NEW!  **FT Graphite Rear Shock Tower, Tall**

#81422 RC8B3.1 FT Graphite Rear Shock Tower, tall.

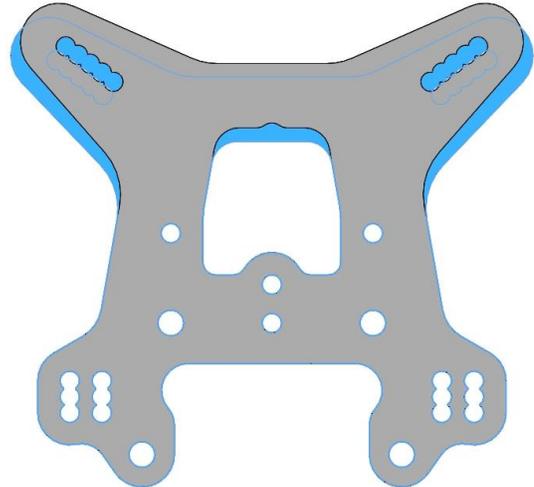
Difference between new #91422 tower (gray) and standard tower (blue). Shock tower holes are higher.

We've raised the top shock mounting positions in our new graphite rear shock tower, resulting in a taller tower geometry.

Taller tower geometry increases up-travel. Up-travel is how much further the shock can travel upwards in its stroke after the chassis has bottomed out with the ground. Increasing up-travel lets the tire absorb more impact and improves handling in bumps and high-speed cornering.

After testing, Area 51 engineers found that by raising the existing shock locations by a specific amount, up-travel is optimized for both low and high axle positions.
